# 2014 - 2016 Corvette: Service Bulletin: #17-NA-278: Convertible Top Creak or Snap Noise While Driving

## #17-NA-278: Convertible Top Creak or Snap Noise While Driving - (Aug 29, 2017)

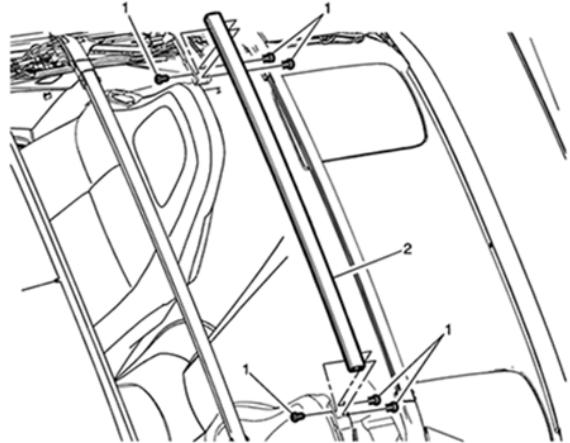
The cause of the condition may be that the fasteners (1) at the ends of the #3 Bow (2) may have lost torque.

Following the Service Procedure below, remove the original smaller screws and install the new larger M6 screws referenced in the Part Table.

1. Starting on either side, replace the current M5 retaining screws with the new M6 self threading screws.

Tighten the screws to 3 Y (27 lb in).
